Product Change Notification / GBNG-16BGIH897

CCB 4628 and 4628.001 Final Notice: Qualification of STA as an additional assembly site for selected LAN9500A, USB2512B, USB2513B, USB2514B and USX2064 device families available in 56L VQFN (8x8x0.9mm) and 36L VQFN (6x6x1.0mm) packages.

CCB 4628 and 4628.001
Pre and Post Change Summary
PCN #: GBNG-16BGIH897

Lead frame Comparison

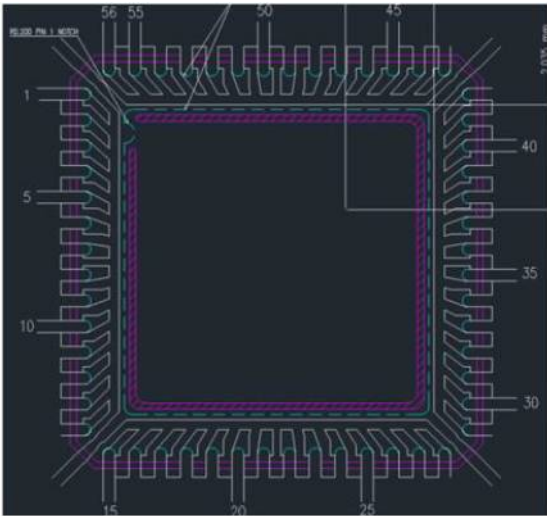
56L VQFN

ASE

STA

Lead frame Comparison

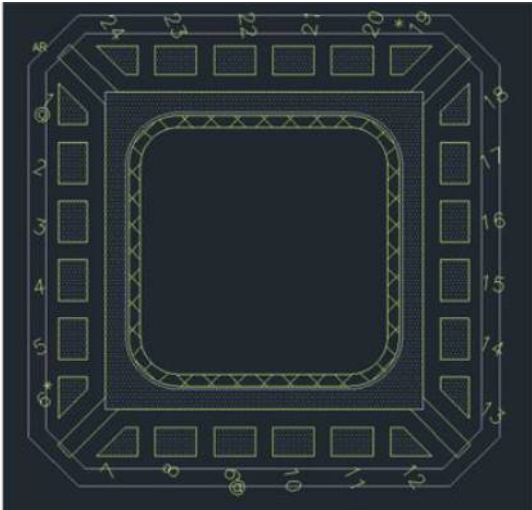
36L VQFN

ASE

STA
